NRC DOCKET 50-321
OPERATING LICENSE DPR-57
EDWIN I. HATCH NUCLEAR PLANT UNIT 1
REVISION TO PROPOSED APRM/RBM
TECHNICAL SPECIFICATIONS

September 6, 1984

ATTACHMENT 2

FIGURE 3.6-5

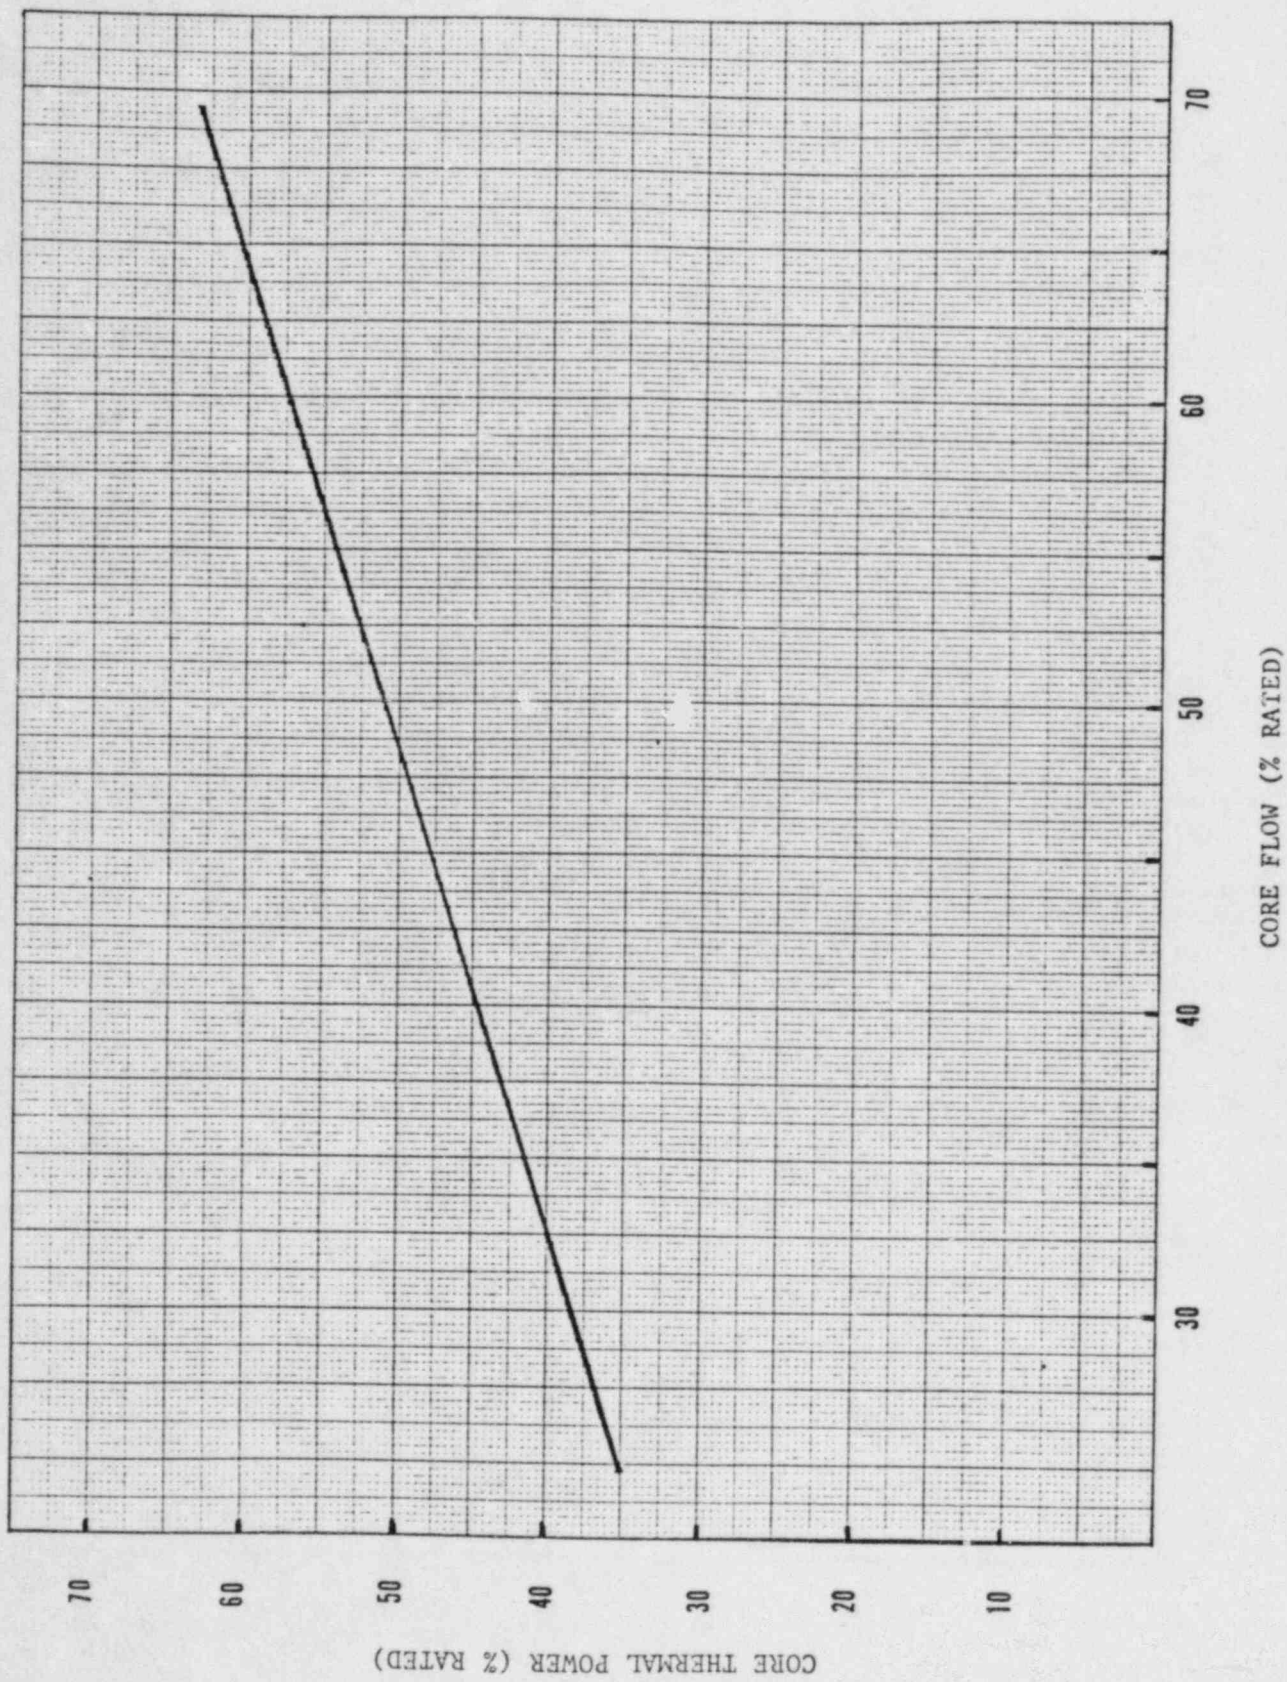
- 1) Add "With one recirculation pump not in operation, initiate action within 15 minutes and continue action to reduce reactor power to or below the limit specified in Figure 3.6-5 within 2 hours." and "... or the limit of Figure 3.6-5 cannot be met within the required time..." to Specification 3.6.J.2, and add Figure 3.6-5 as a new page.

This change would restrict plant operation to the region at or below the limit shown in Technical Specifications Figure 3.6-5, within 2 hours after either recirculation loop is declared inoperable. That limit corresponds to a load line leading to 80% reactor power at rated core flow. This constitutes an additional restriction not presently in the Technical Specifications; therefore, this proposed change is consistent with Item (ii) of the "Examples of Amendments that are Considered Not Likely to Involve Significant Hazards Considerations" listed on page 14,870 of the April 6, 1983, issue of the Federal Register.
